# Staff Report

Knoxville Historic Zoning Commission

File Number: 12-A-25-HZ

**Location:** 1618 Clinch Ave. **Parcel ID** 94 N H 013  
**District:** Ft. Sanders NC  
**Zoning:** O (Office)  
**Description:** Queen Anne with Neoclassical influence, c.1907

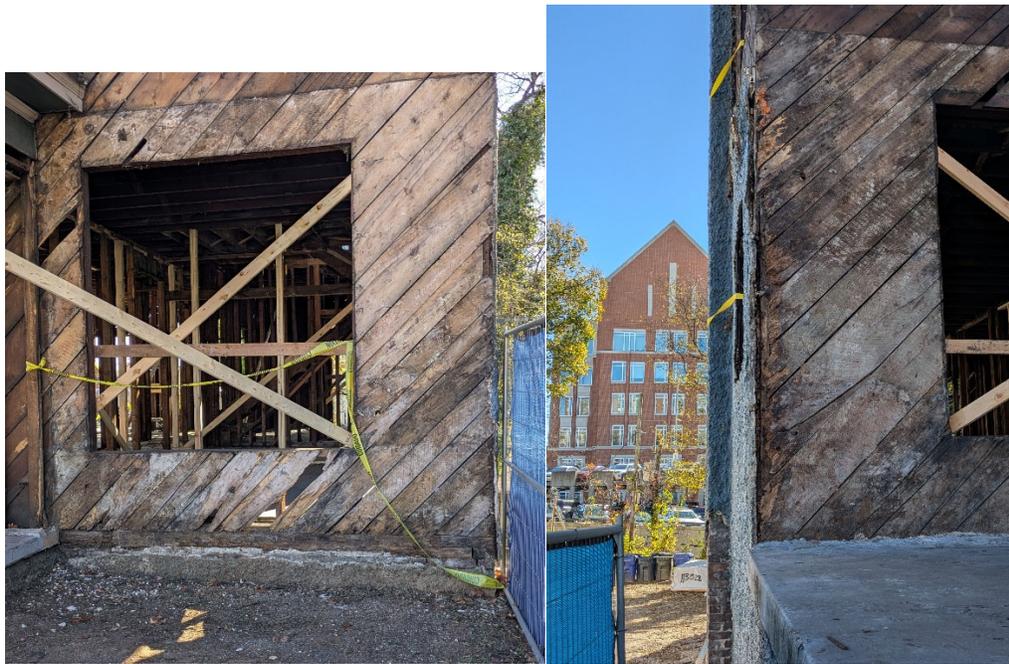
Rot at wood/sill in contact with stucco

Depiction of two wythe foundation

area of foundation falling apart

Evidence of mortar integrity loss

sill plate rot and foundation issues

Brick easily removed due to fretting

prior foundation repair at front of house

Fretting at chimney base

fretting at interior of building
